# Access Compliance Report

## Public Rights-of-Way

### (Curb Ramps)

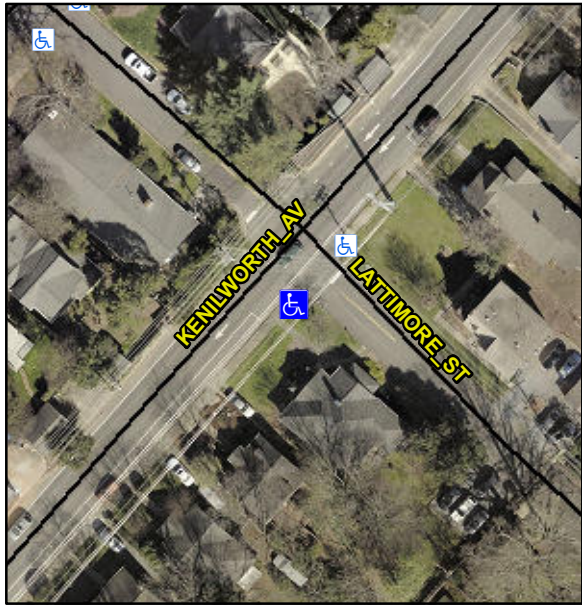
Intersection ID: 15368		Main Street: KENILWORTH_AV		Cross Street: LATTIMORE_ST		Location: S							
ADA ID: BEF56BF3BF4F		Ramp Type: Directional2		Initial Pass/Fail: Fail		Overall Compliance: No		Severity Score: 25					
Codes/Mitigation Info/Possible Solution				Field Measurements/Component Compliance									
<div></div> <div>Possible Solutions: <b>Remove &amp; Replace Entire Ramp.</b></div> <div>Surveyor Notes: <b>N/A</b></div> <div>PROW/ADA: <b>R304.5.3</b></div> <div><div>Street 1 NameLATTIMORE_ST</div><div>Stop Condition-Street 1StopSign</div><div>Street 2 NameN/A</div><div>Stop Condition-Street 2N/A</div></div>				Compliance	Description	Data	Compliance	Description	Data				
				N/A	Ramp Length (in)	53.0	N/A	Grade Break?	N/A				
				Yes	Ramp Width (in)	60.0	N/A	Grade Break Slope (%)	0.0				
				Yes	Ramp Slope (%)	5.6	N/A	Grade Break XSlope (%)	0.0				
				No	Ramp XSlope (%)	8.5							
				N/A	Flare Type LT	N/A	N/A	Flare Type RT	N/A

N/A	Flare Slope LT (%)	N/A	N/A	Flare Slope RT (%)	0.0				
				N/A	Flare Traversable LT?	N/A	N/A	Flare Traversable RT?	N/A				
				N/A	Landing Length (in)	0.0	N/A	DWS Provided?	N/A				
				N/A	Landing Width (in)	0.0	N/A	DWS Contrast?	N/A				
				N/A	Landing Slope (%)	0.0	N/A	DWS Length (in)	N/A				
				N/A	Landing X Slope (%)	0.0	N/A	DWS Full Width?	N/A				
				N/A	Landing Curb? (Y/N)	N/A	N/A	DWS Offset LT (in)	N/A				
				N/A	Shared Landing?	N/A	N/A	DWS Offset RT (in)	N/A				
				N/A	Gutter Ponding?	0.0	N/A	Gutter Slope (%)	N/A				
				N/A	Gutter Lip Ht (in)	0.0	N/A	Gutter X Slope (%)	N/A				
				N/A	Painted X Walk1?	No		Road Slope (%)	1.0				
					X Walk 1 Direction	To NE		Road X Slope (%)	0.0				
					X Walk 1 Width (in)	N/A		Clear Space?	N/A				
					X Walk 1 Slope (%)	1.0	N/A	Clear Space to XWalk (in)	N/A				
					X Walk 1 X Slope (%)	0.0	N/A	Storm Grate/Utility Hazard?	N/A				
				N/A	Ramp inside XWalk1?	N/A		Storm Grate/Utility Type

N/A	Any Obstructions?	N/A			N/A				
					Obstruction Type		Yes	Surface Condition? (G/P)	Good				
							N/A	Curb Slope (%)	16.4				
				Total Cost:				\$	1800.00
